**DEVELOPMENT REVIEW COMMITTEE MEMORANDUM**

**VILLAGE OF LIBERTYVILLE  
COMMUNITY DEVELOPMENT DEPARTMENT  
200 EAST COOK AVENUE  
LIBERTYVILLE, ILLINOIS 60048-2090**

**CASE NOS.: PC 25-19 Planned Development Final Plan  
PC 25-20 Final Plat of Subdivision**

**Subject:** **126-140 Lake St & 731 N Milwaukee Ave – Proposed Mixed Use Development Request for Planned Development Final Plan**

**Release Rate Calculation (Qr) and Restrictor Sizing Calculation**  
(EAST WATERSHED AREA)

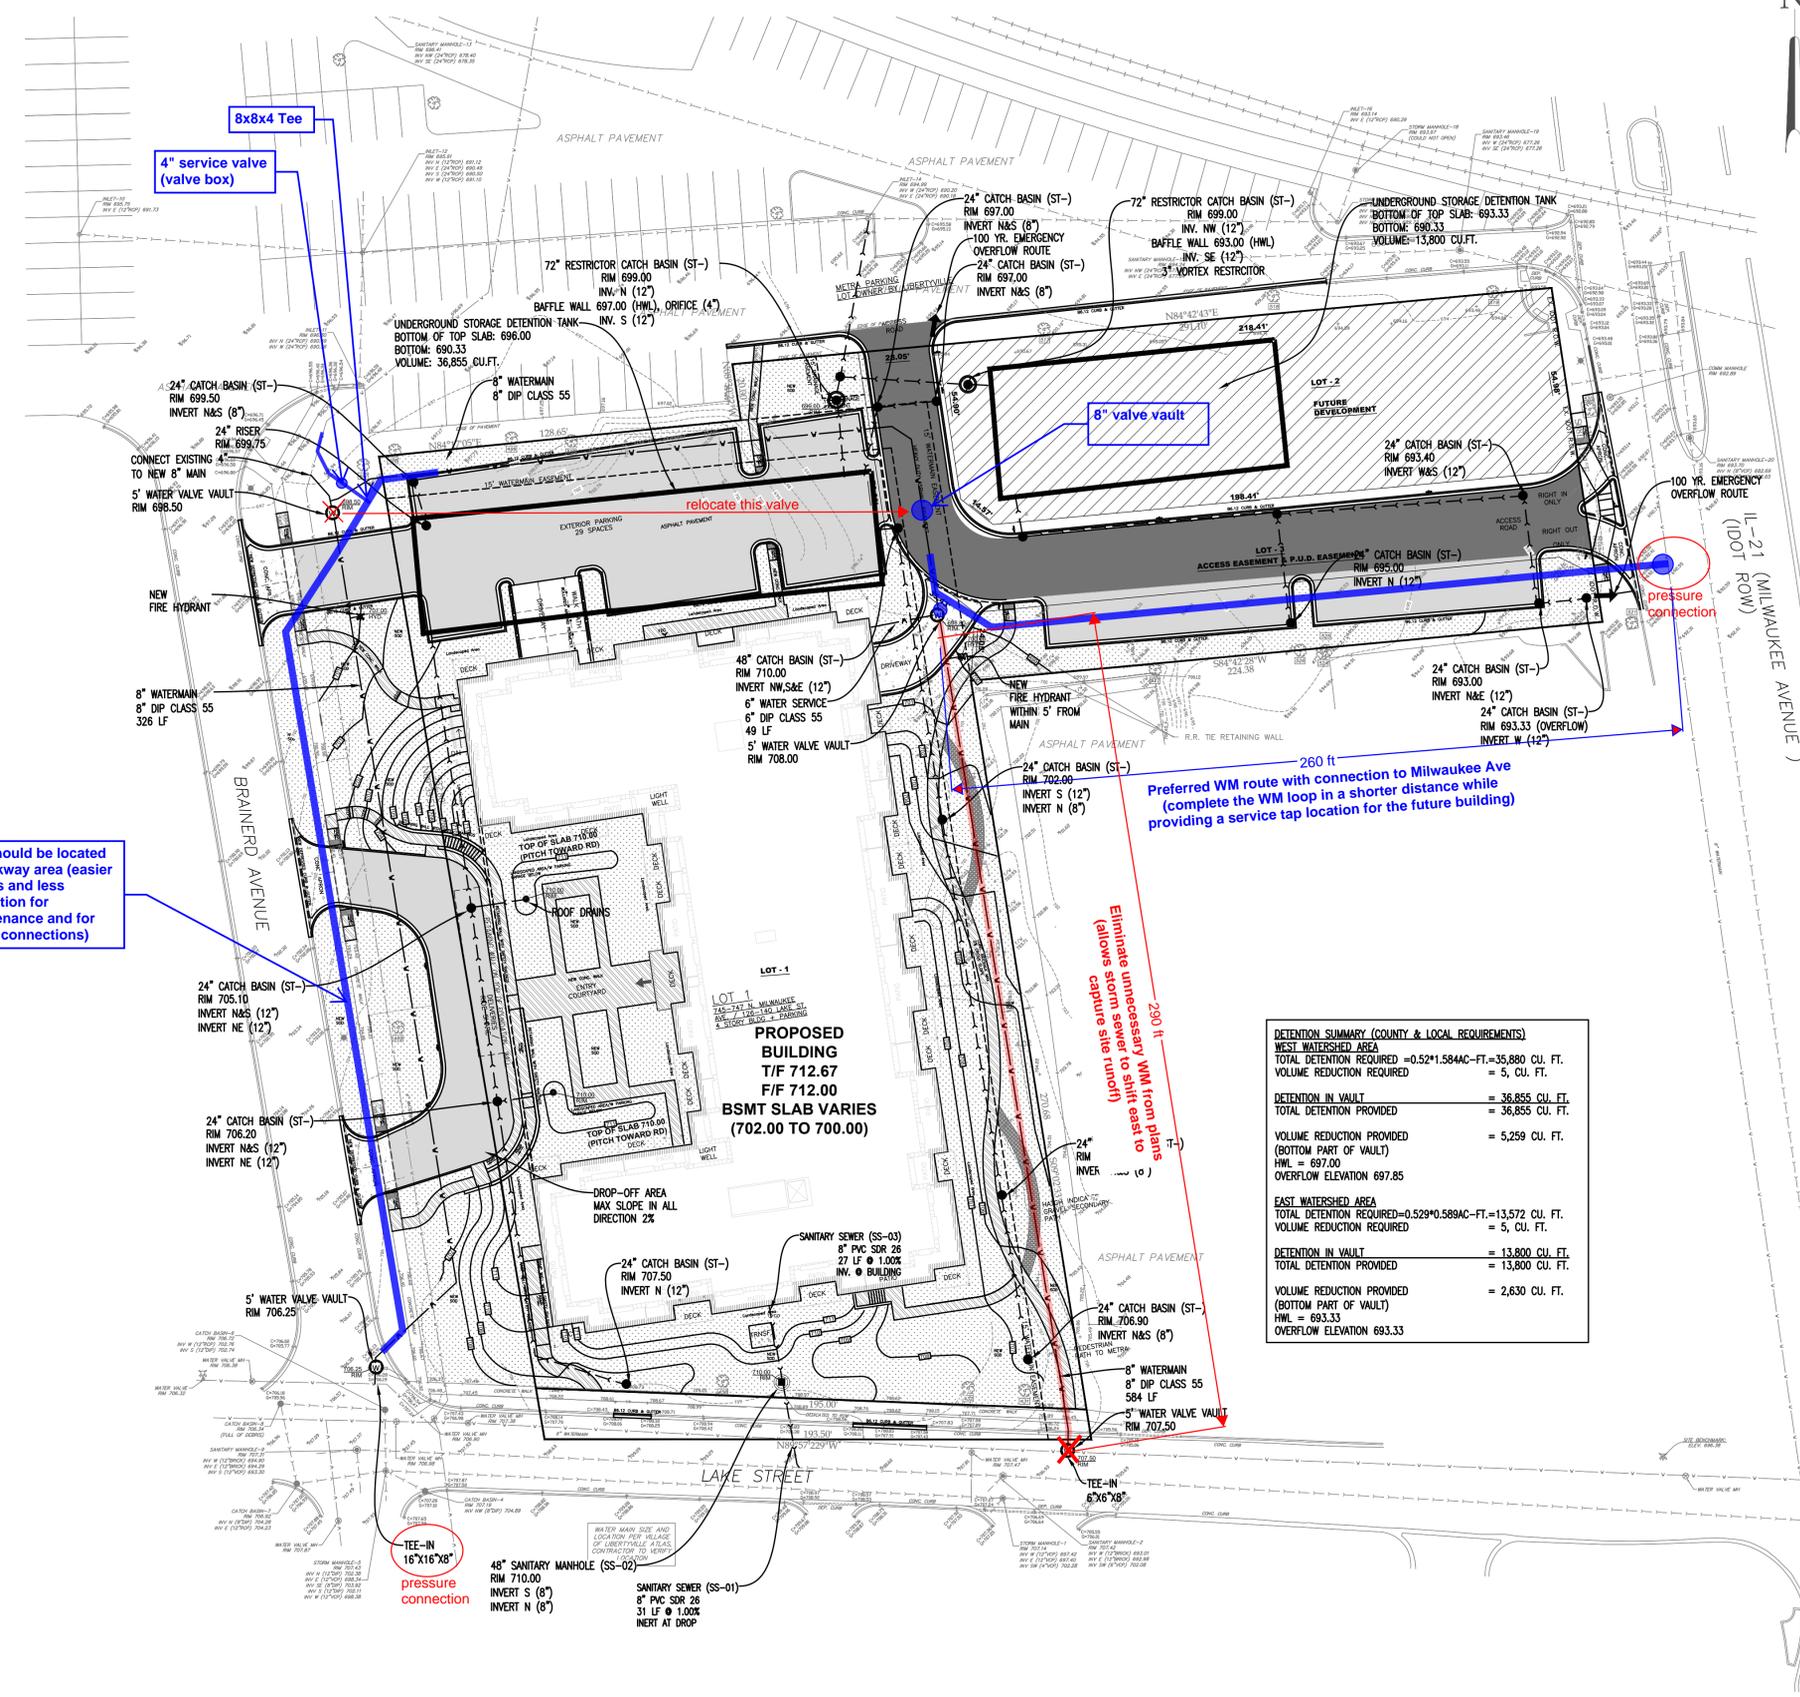
- b. The submittal does not clarify where volume reduction is provided with respect to the detention outlet inverts. This information remains to be provided for verification of conformance with the ordinance requirements, and it's anticipated that the detention vault shop drawings will be needed as part of the verification.
- c. Required volume reduction figures are incomplete and need to be corrected / clarified within the Detention Summary tables.
